# Planning report

**2023/2860**

**Land at 12 and Land West of  
10 to 26 Claygate Lane Esher Surrey KT10 0AQ**

This planning report has been prepared by Living Space Architectural Design, who were commissioned by residents adjacent to the site to assess the planning application 2023/2860 in light of relevant policies.

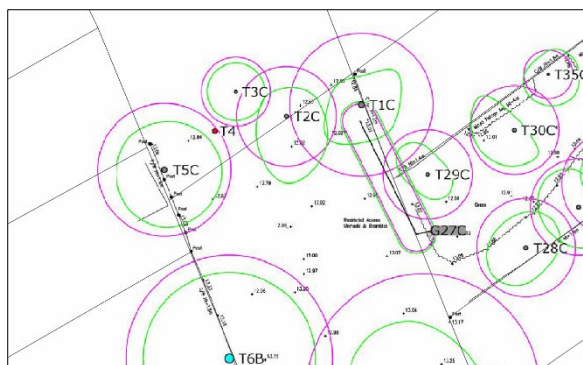
The Arboricultural Statement provided is flawed and contradicts Tree Preservation Order EL:12/24 <https://edocs.elmbridge.gov.uk/IAM/IAMCache/2003126/2003126.pdf>.

Tree constraints plan - detail, including Land Registry parcels

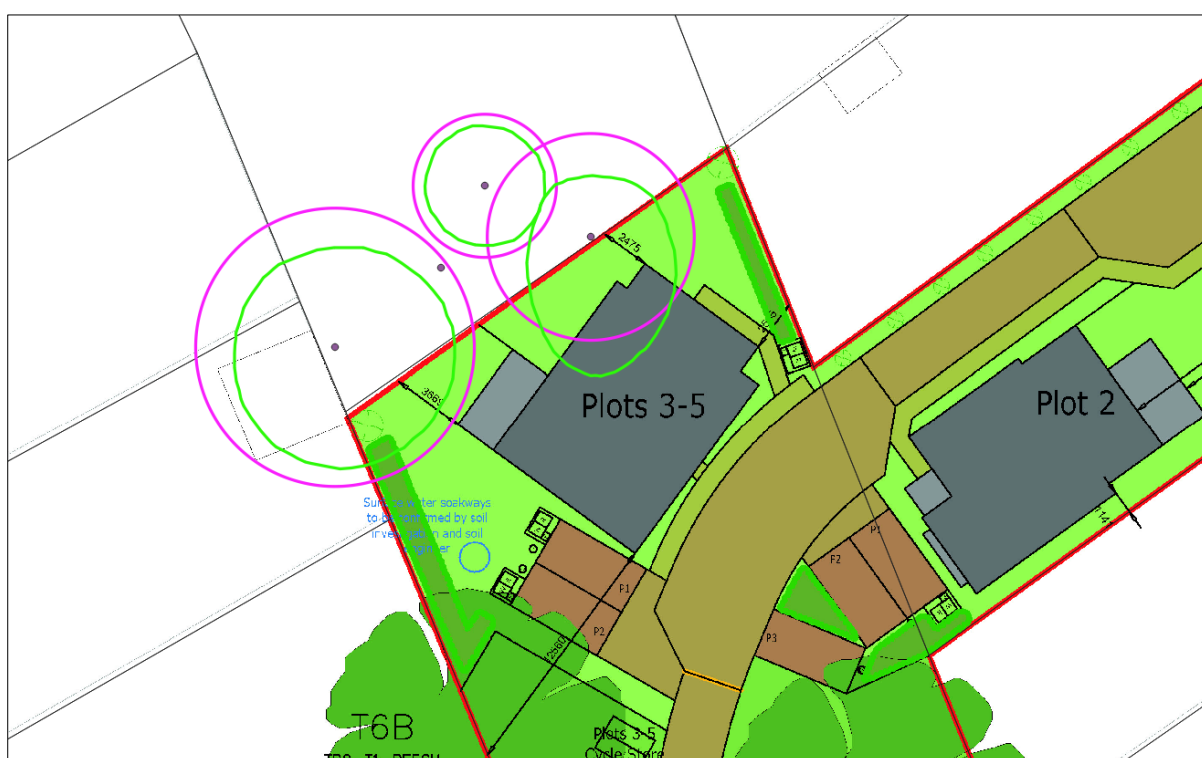
Trees T2 and T5, both in the garden of The Woodlands, 112 Manor Road North, have RPAs which extend onto the site. The arboricultural report proposes removal of the trees – however, the owner of 112 Manor Road North intends to retain both trees, and therefore their RPAs must be

respected. The foundations for the proposed flats (Plots 3-5) would cut directly through the RPA of T2, and come extremely close to the RPA of T5. No protection / tree fencing is proposed for T5.

Position, canopy and RPA of T5, T3, T2, T4 (dead tree - canopy and RPA not shown) superimposed on proposed site plan. T5, T3 and T2 will be retained by the owner.
